Response to Instructor Comments

Movable Impact Testing Platform

Team #2

Figure 1: Final hydraulic circuit diagram of the Movable Impact Testing Platform. The diagram shows the hydraulic oil reservoir, hydraulic pump, relief valve, pressure gauge, servo proportional directional valve, double-acting hydraulic cylinder, pressure line, and return line.

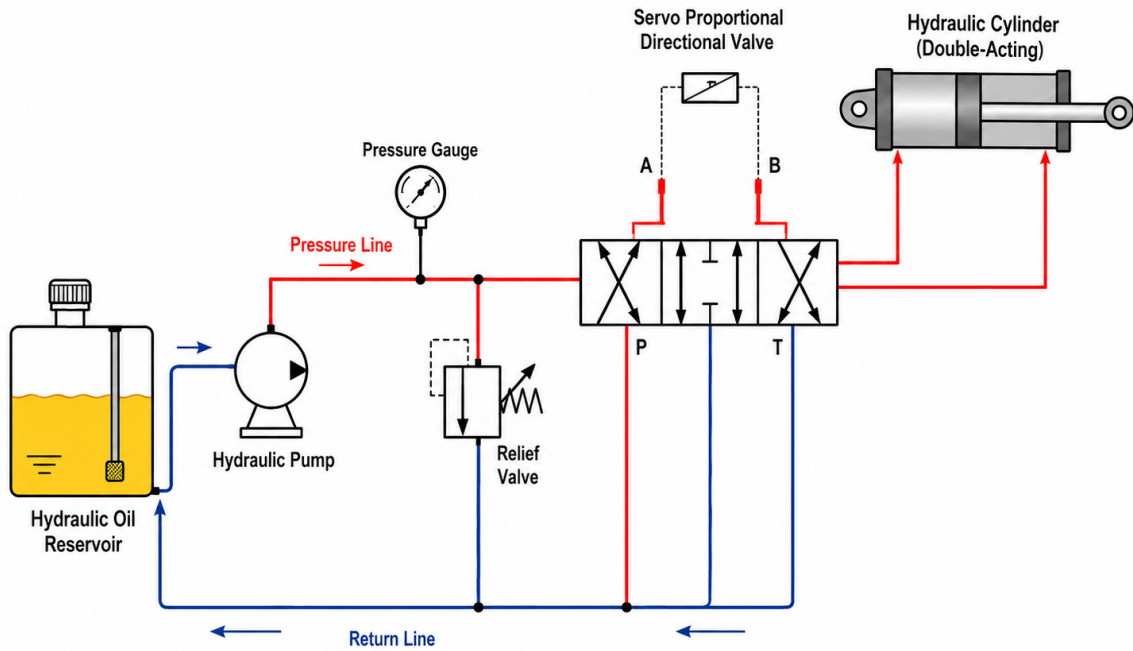
There are two missing figures for the final hydraulic circuit on page 9 and the voltage switching logic on page 11. Please add these, as well as the PCB layout if available. The report uses photographs instead of diagrams. Nicely labelled diagrams are usually easier to interpret than photographs.

We sincerely thank the instructor for this important comment. We agree that the draft report relied too heavily on photographs and did not provide enough labelled engineering diagrams. Although photographs are useful for showing the assembled prototype, they do not clearly explain the hydraulic flow path, the valve control logic, or the electrical signal routing. We therefore added labelled diagrams and the PCB layout for the valve-command generation circuit to the supplementary document.

First, a final hydraulic circuit diagram has been added. This diagram shows the hydraulic oil reservoir, hydraulic pump, relief valve or pressure-control component, pressure gauge, servo proportional directional valve, hydraulic cylinder, pressure line, and return line. The purpose of this figure is to make the fluid path clear and to show how the pump supplies pressurized oil to the valve and how the valve directs the flow to extend or retract the cylinder.

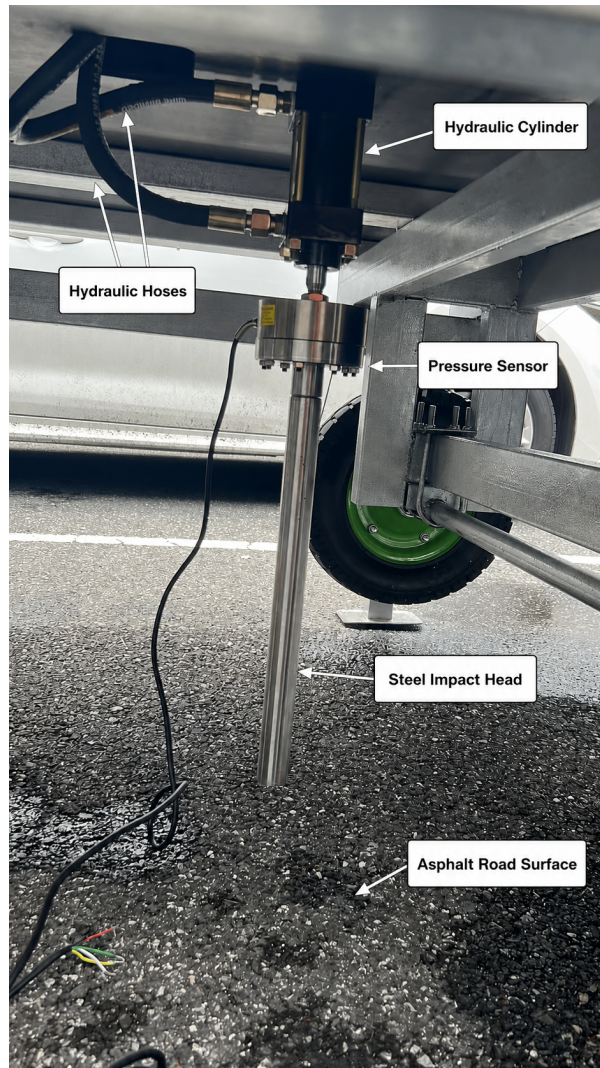
Please add some additional quantitative results, such as measured pressure and force. If you cannot obtain the force measurement, explain why not. It is also noted that the valve command voltage test produces no specific quantitative metric but only a qualitative claim that the requirement is satisfied. Please add some type of quantification of this verification.

We sincerely thank the instructor for this comment. We agree that the original verification section did not provide enough quantitative evidence. To address this issue, we added a quantitative force verification based on the hydraulic impact experiment.

As part of the experimental work, which also forms part of Yihang Shen's senior thesis, the hydraulic exciter was tested with a steel impact head striking an asphalt road surface at an approximately 4.2 Hz operating frequency. In this setup, the circular component mounted between the actuator output and the steel impact head was the pressure sensor used in the test, as shown in Fig. 4. The hydraulic cylinder piston diameter was 50 mm, and the directional valve supplied hydraulic oil at approximately 4 MPa.

This result shows that the experimentally obtained force is in close agreement with the theoretical hydraulic-force estimate. Therefore, the supplementary document now includes a clear quantitative verification of the hydraulic output. In addition, the valve-command verification will be quantified in the revised report by reporting the measured positive voltage, negative voltage, and switching frequency of the ± 10 V control signal.
